UNITED STATES PATENT AND TRADEMARK OFFICE

10/528,400

Office Action Summary	Application No. 10/528,400	Applicant(s) SIEKE ET AL.	
	Examiner Edward F. Landrum	Art Unit 3724

DETAILED ACTION

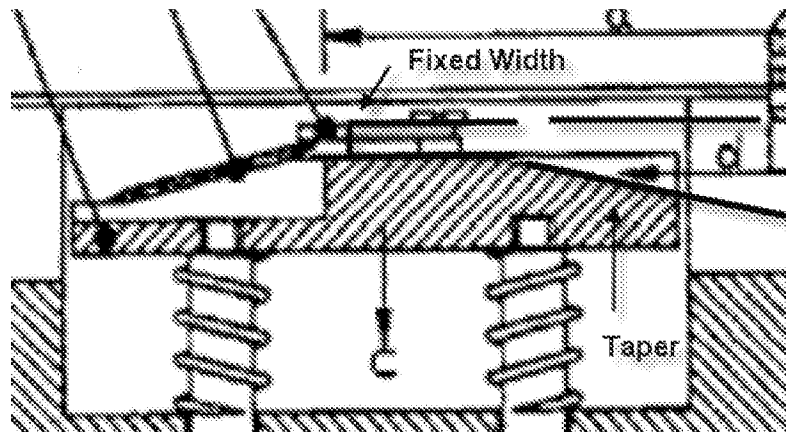
Wessels does teach a fixed with channel as explained in the 102(b) rejection above and shown with this drawing below.

Examiner never states that the springs maintain a fixed width between them but instead states "The second guide tapers in a direction of movement of the material being cut (6) from a large width to a fixed width (depth of guide decreases as guide portion 2 tapers upwards to a fixed height towards the top of the second guide 4 in a

direction of movement of the material being cut). There is no reason why the depth and the width cannot be the same measurement. However, examiner has provided a second rejection involving a fixed distance between two side portions of a guide adjacent the lip if applicant argues the 102(b) rejection.
